AGENDA
JANUARY 13, 2026

Application 25-25 15 Plum Tree LLC-Permit approval to construct a 3 story apartment building & 9 attached townhouses, a retaining wall, subsurface stormwater detention system, level spreader, sidewalks and storm drainage within a regulated area at 5 & 15 Plumtree Lane.

MILL RIVER PARK 5 & 15 PLUMTREE LANE TRUMBULL & EASTON, CONNECTICUT

EXISTING
CONDITIONS

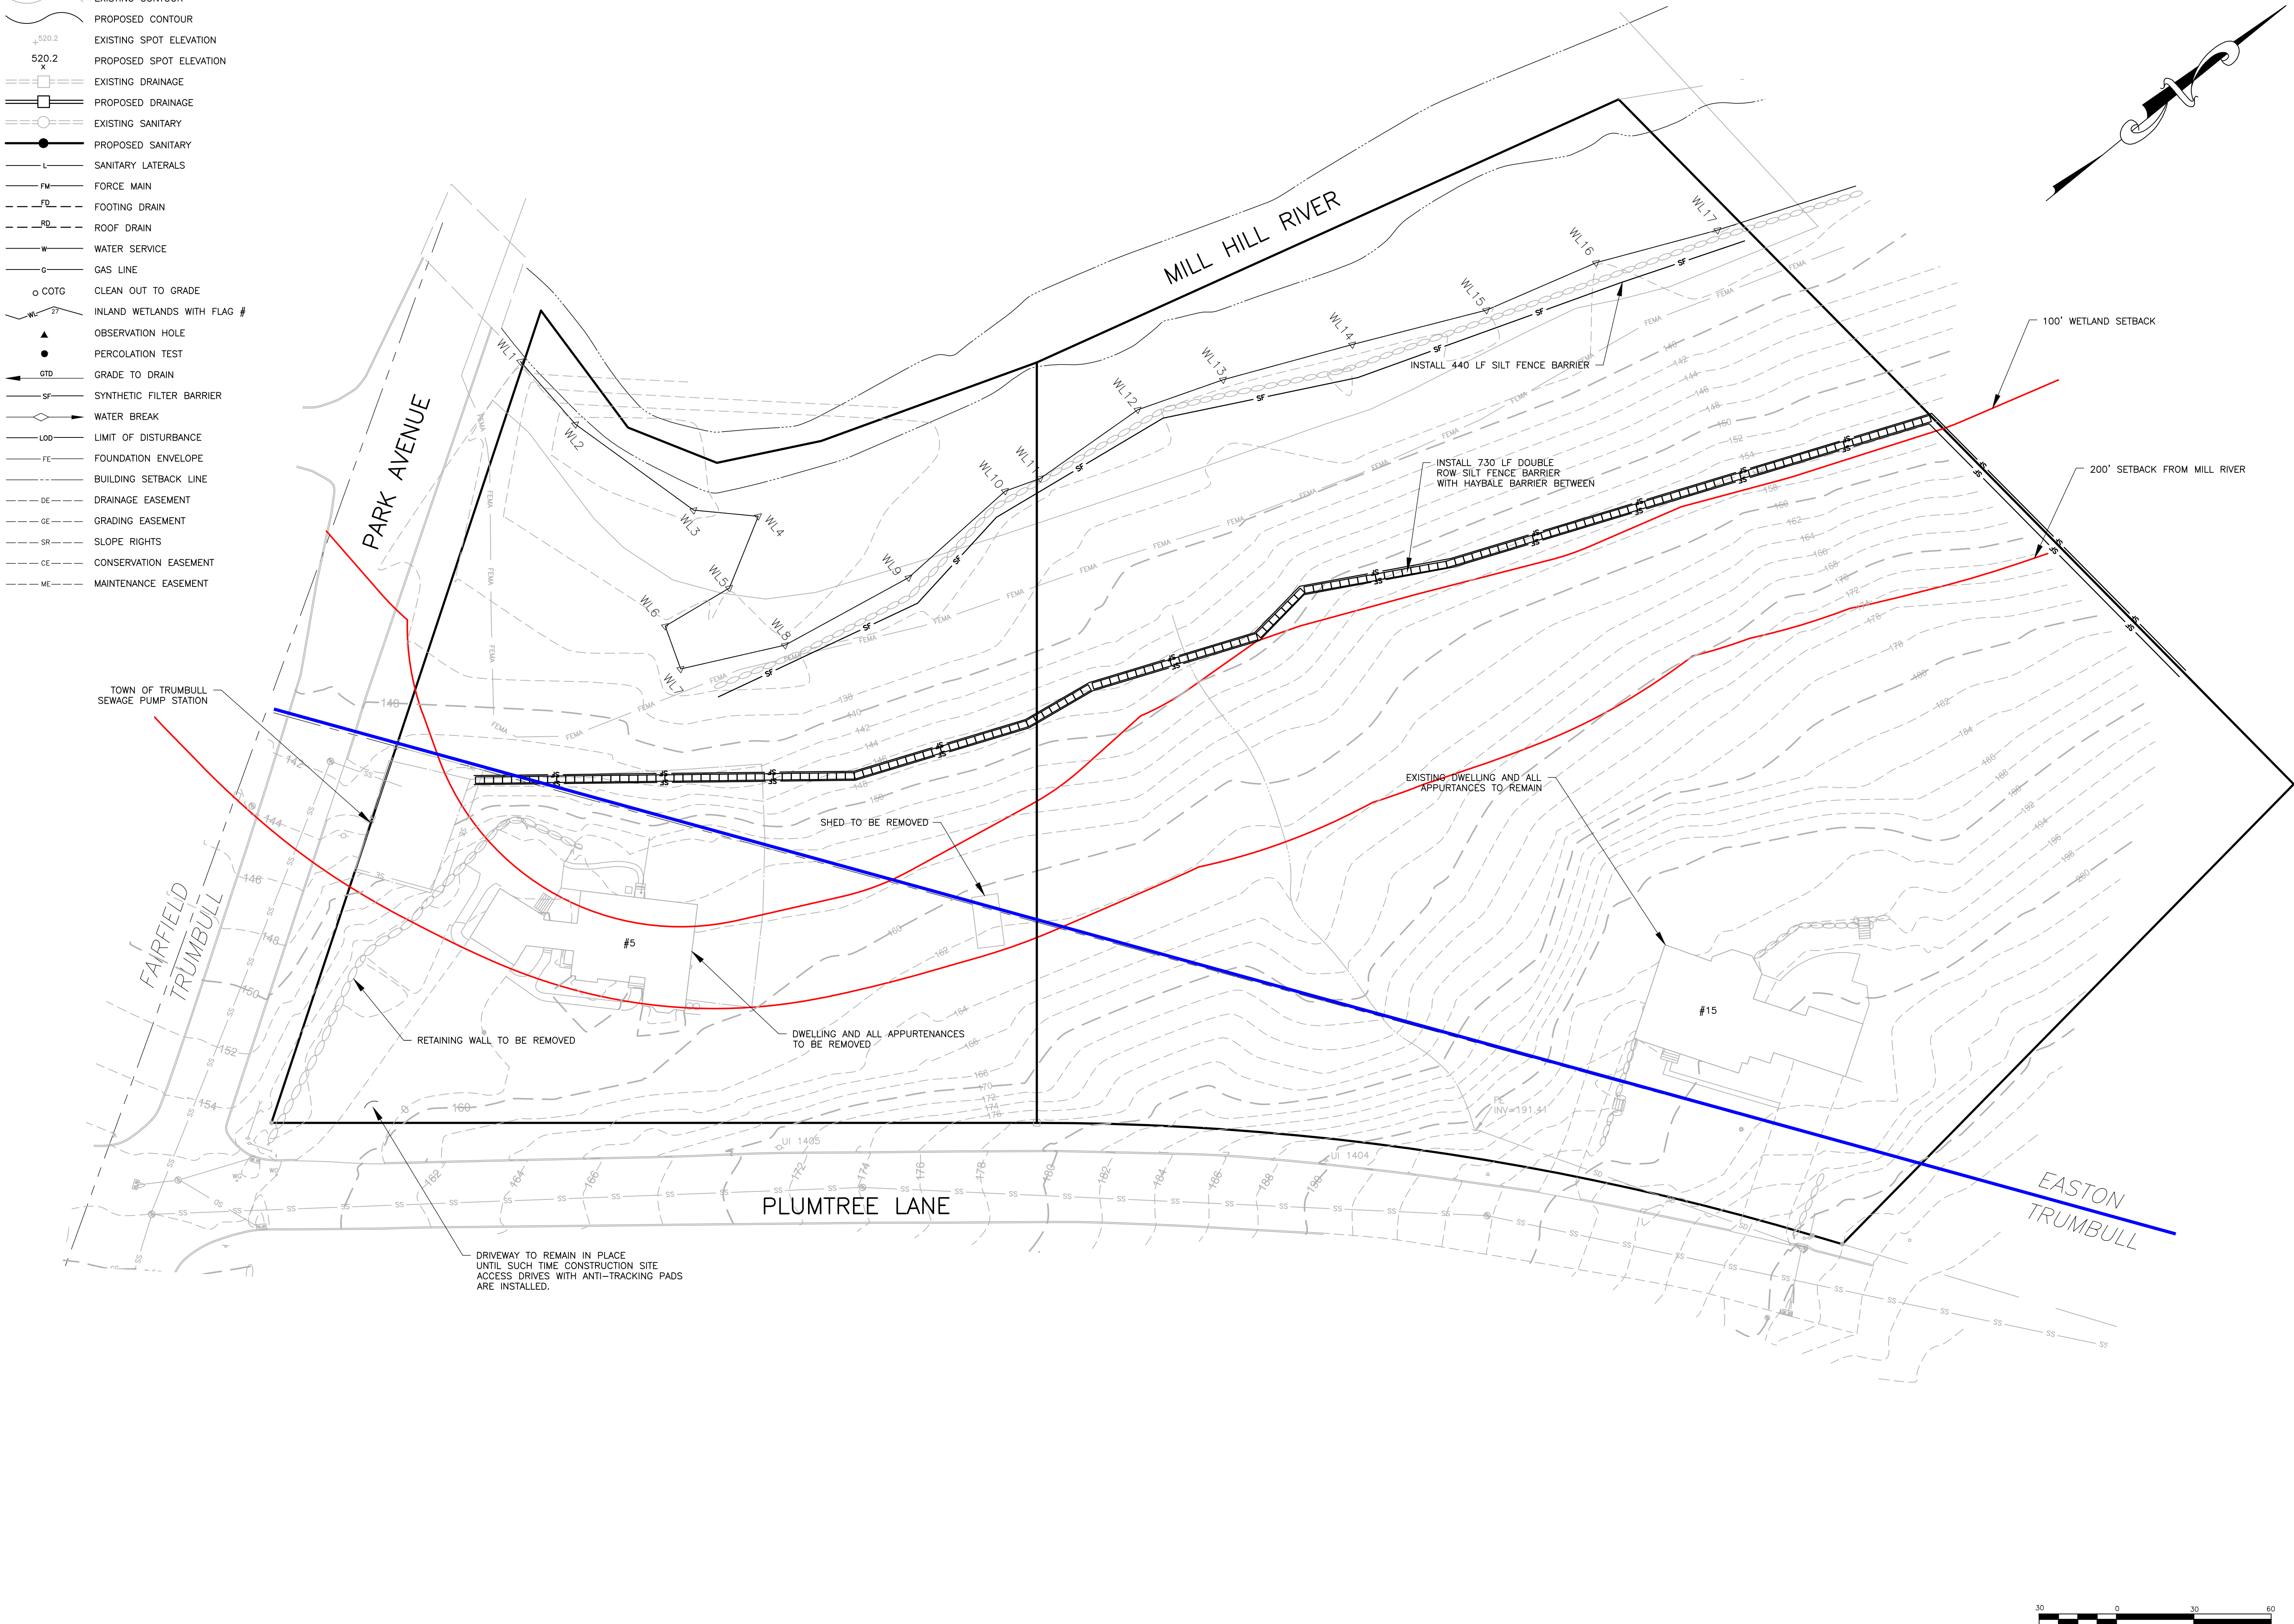
Sheet 1.1:

Sheet 1.1. – Existing Conditions:

SITE PLAN

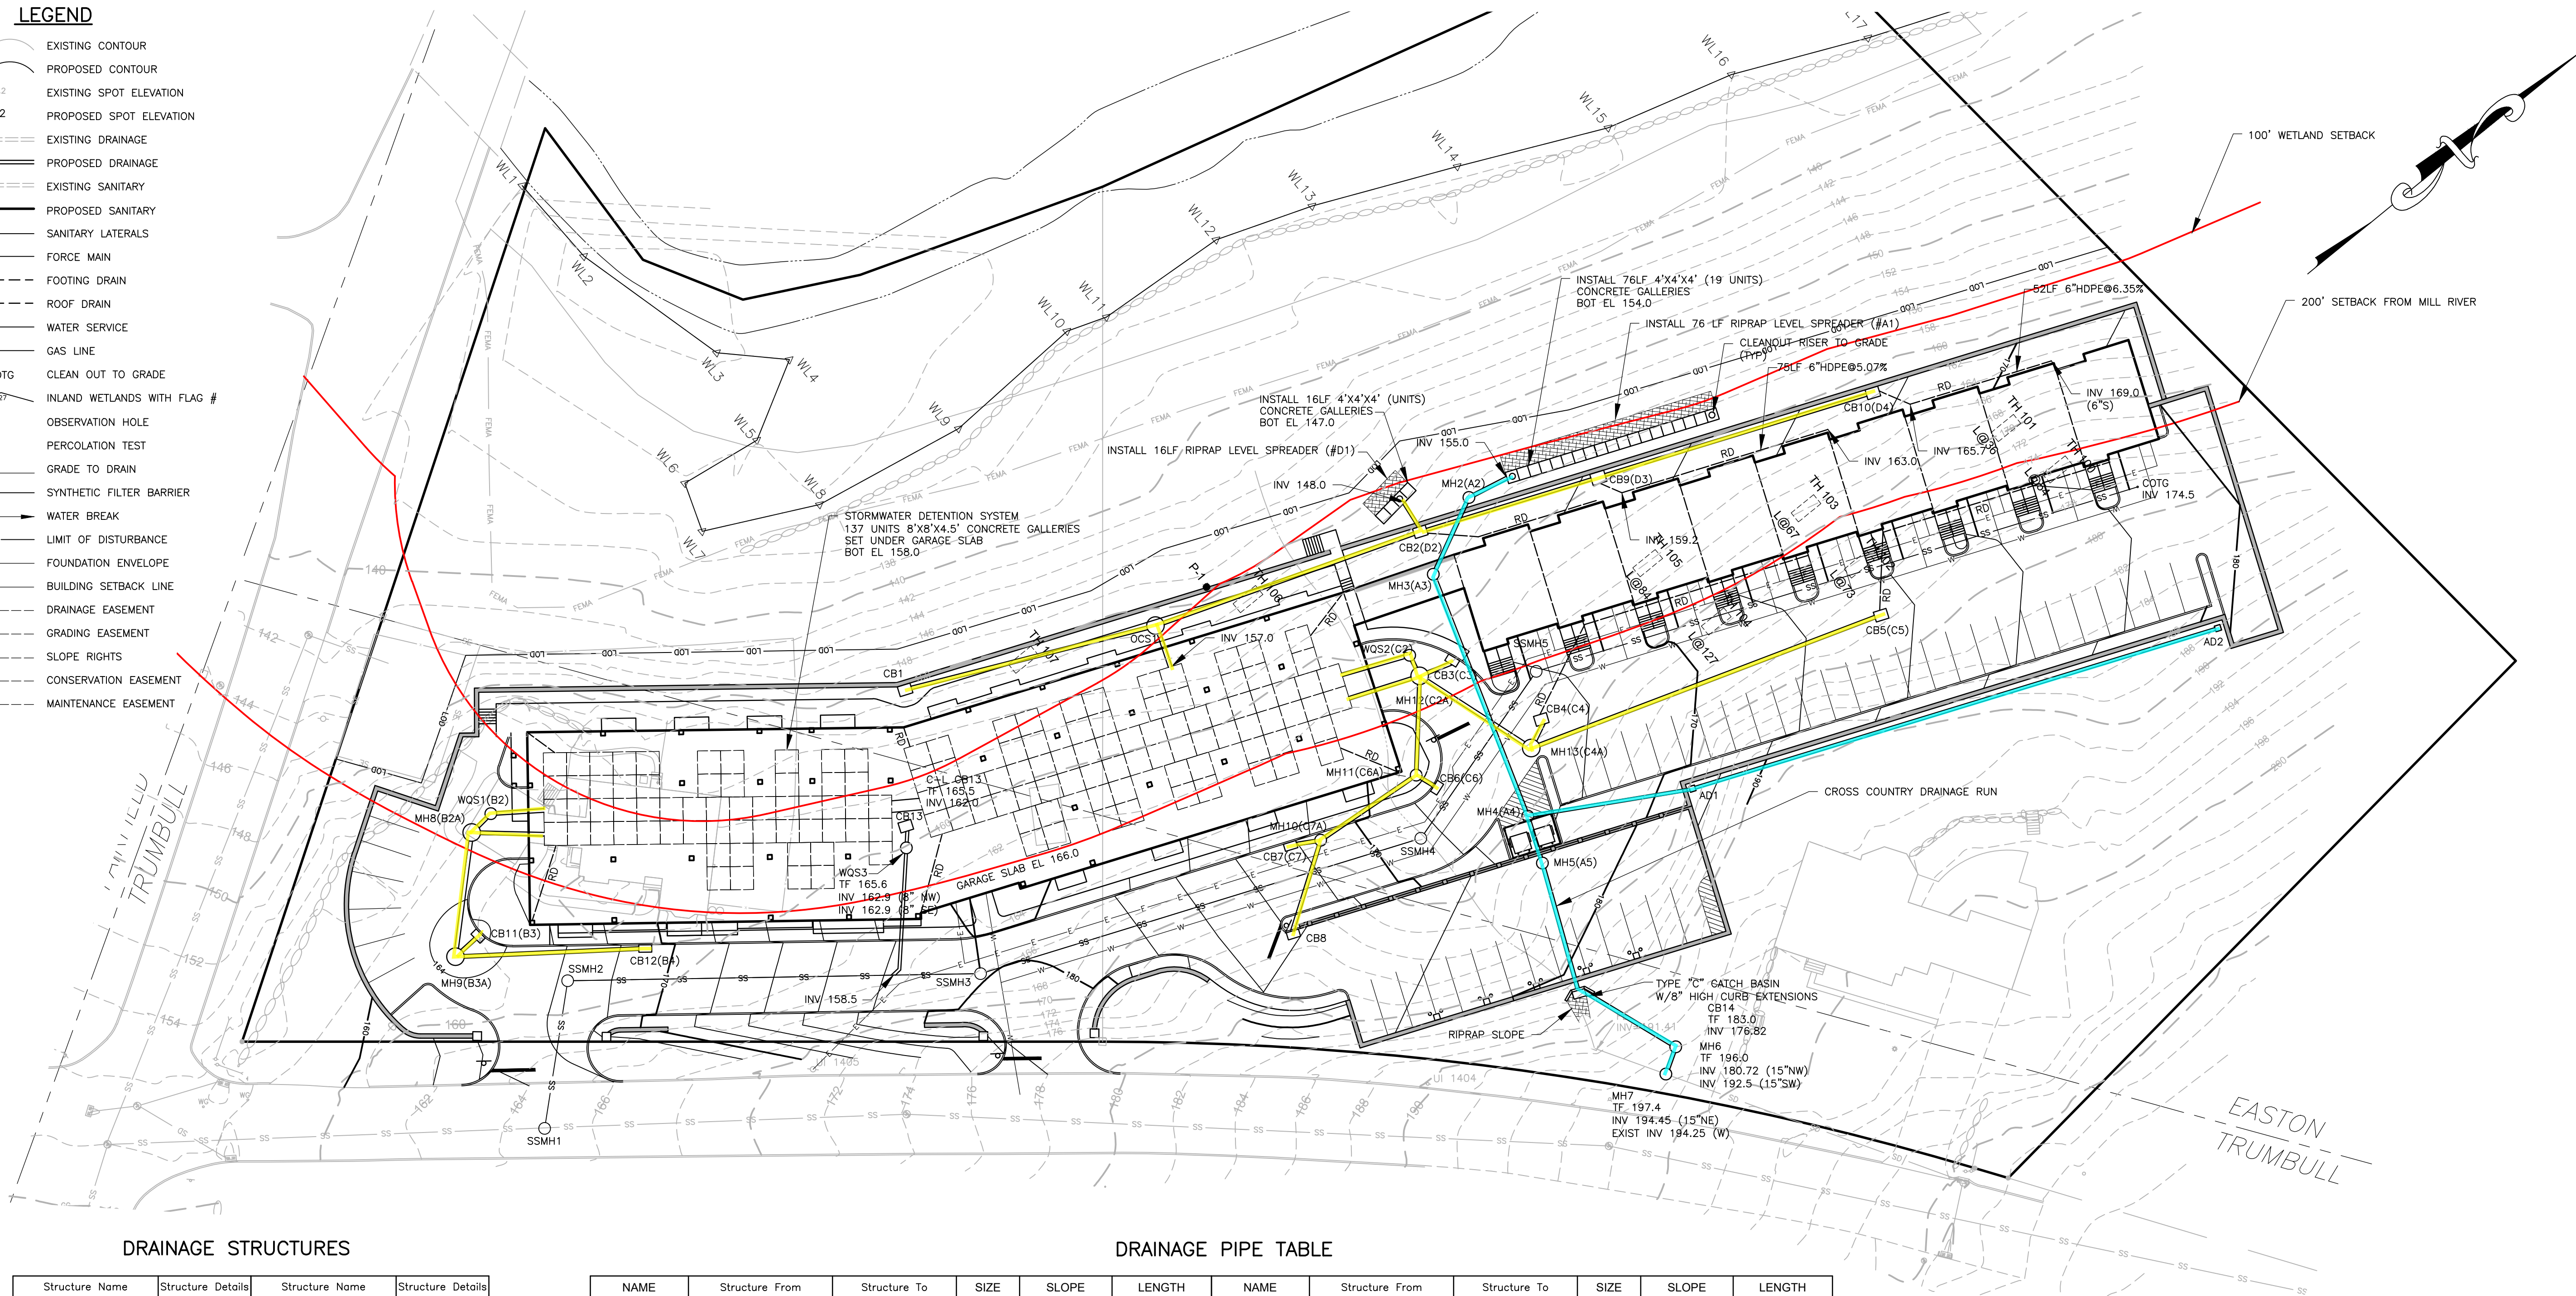
Sheet 2.1 (site plan):

Sheet 2.1 – Site Plan:

**UNDERGROUND
UTILITIES PLAN**

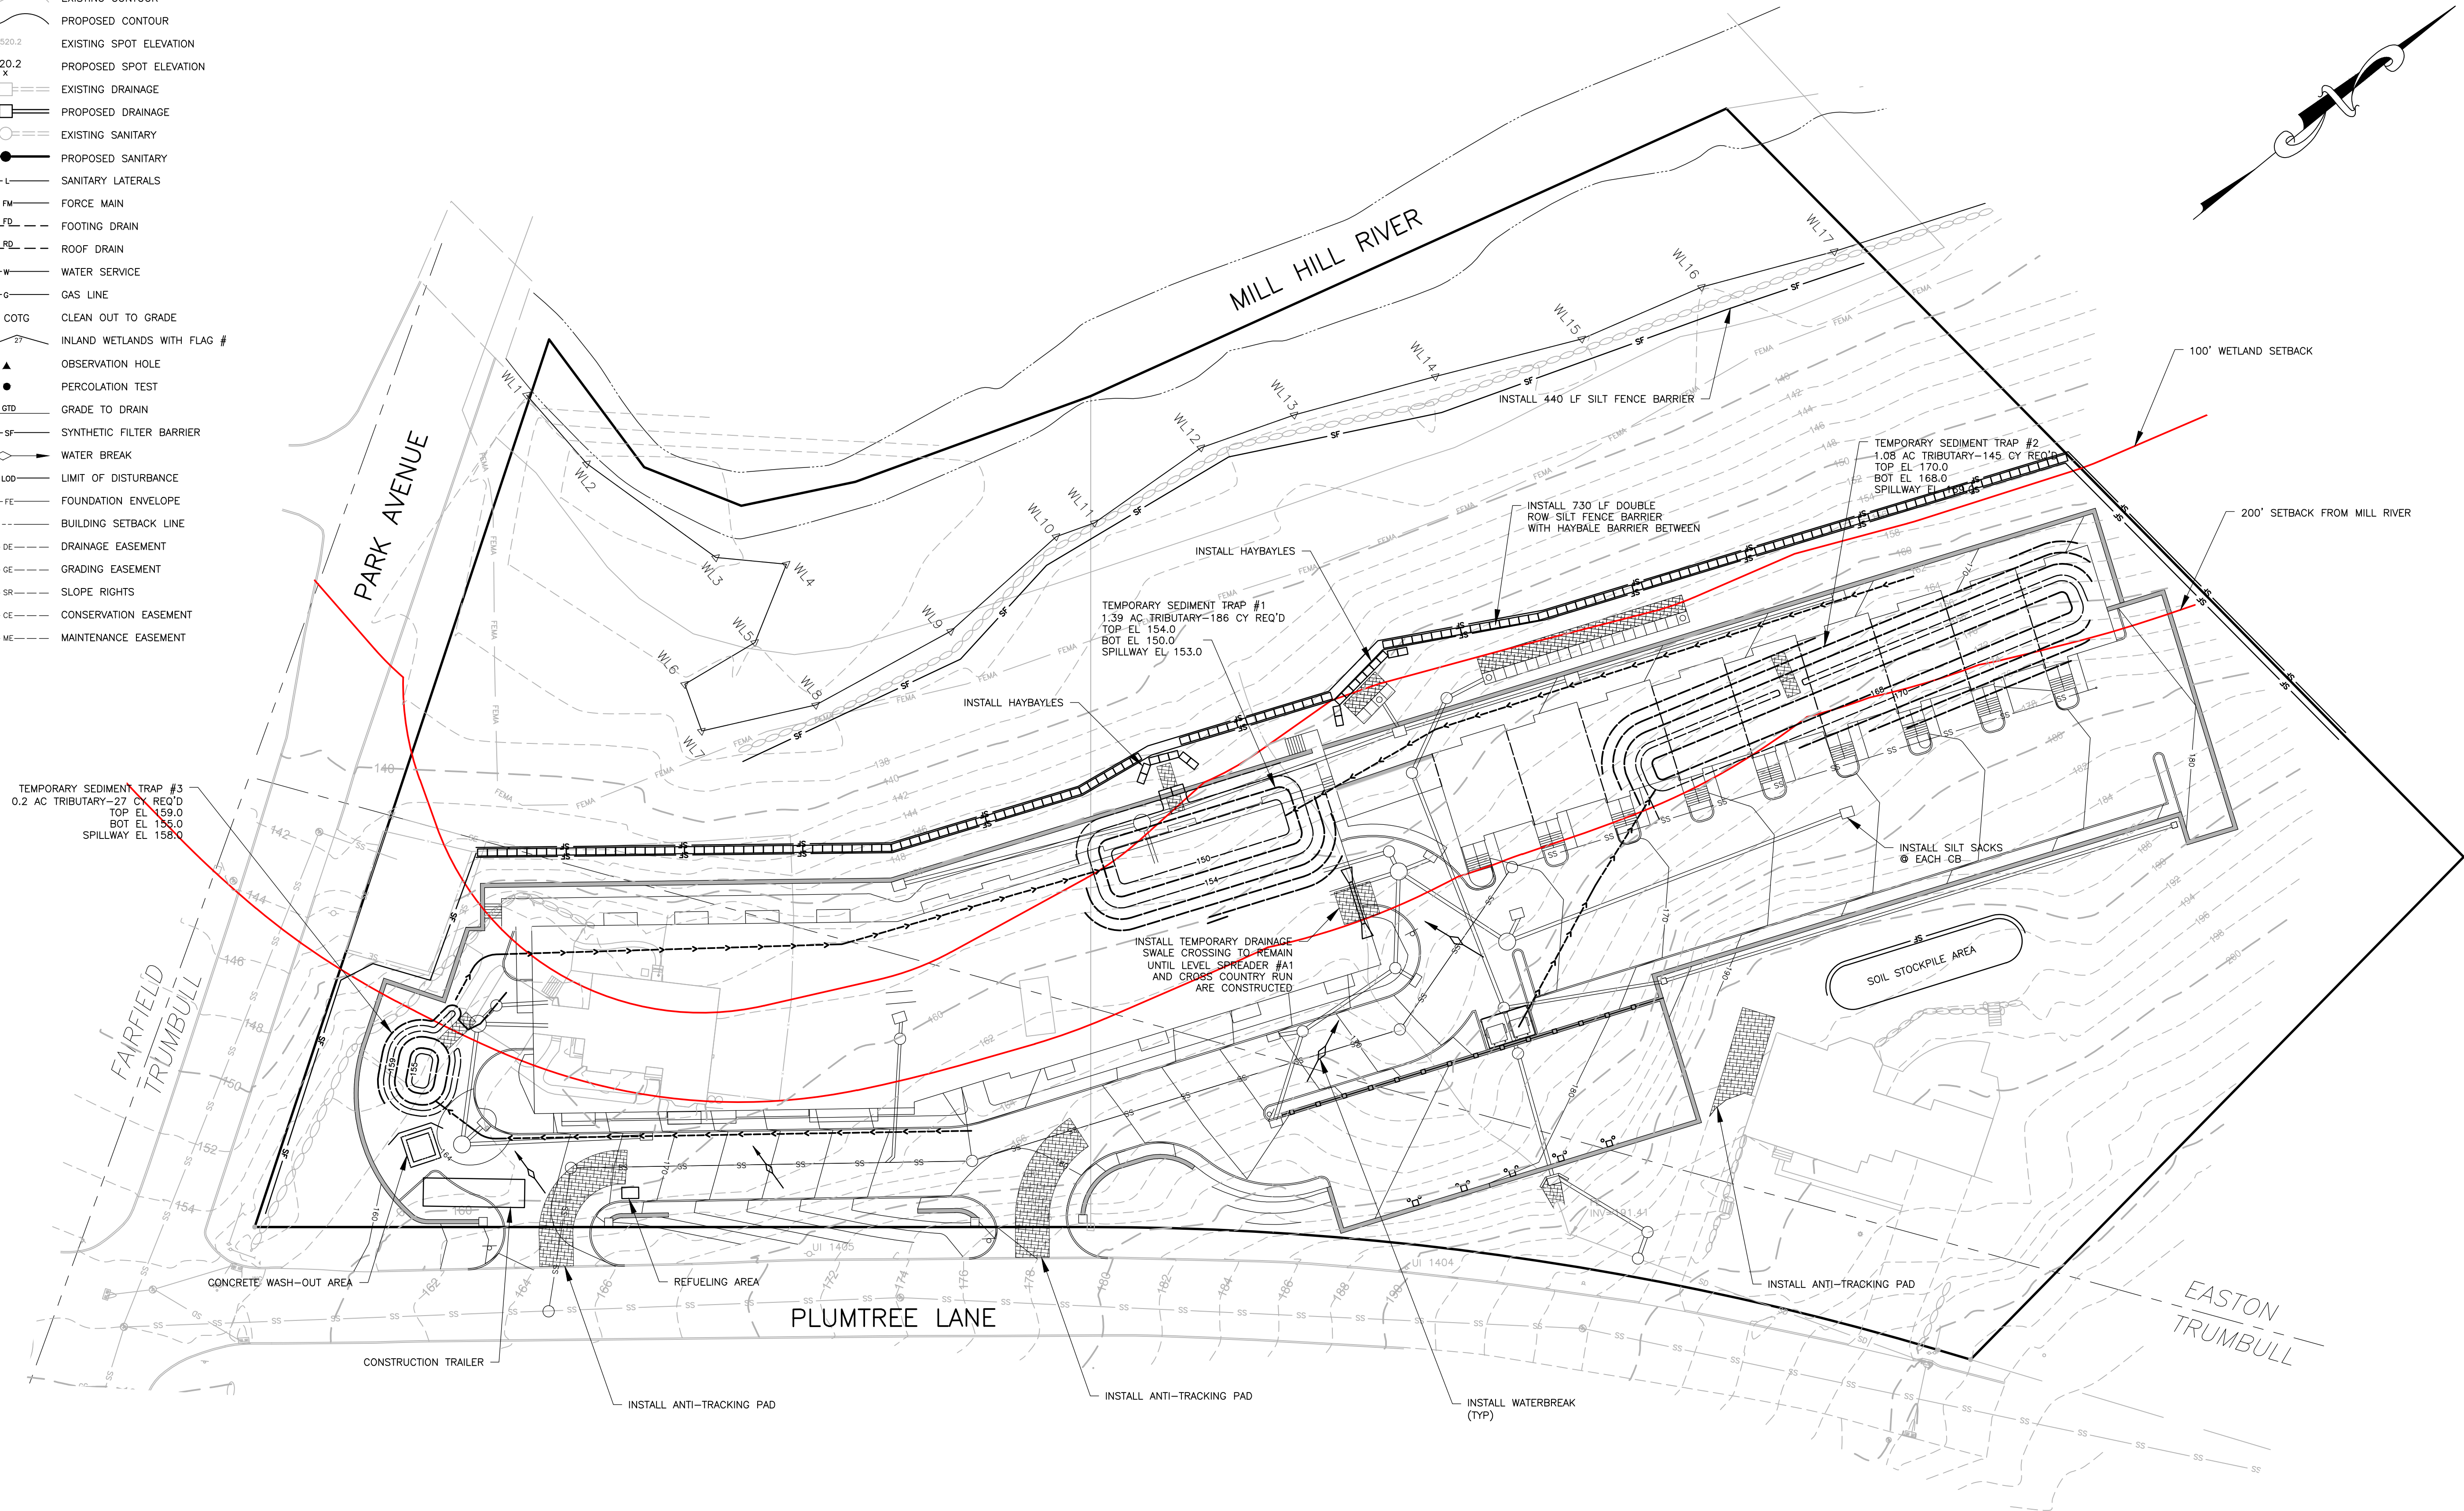
Sheet 2.1 (underground utility plan):

Sheet 2.2 (Misabeled as 2.1) – Underground Utilities Plan:
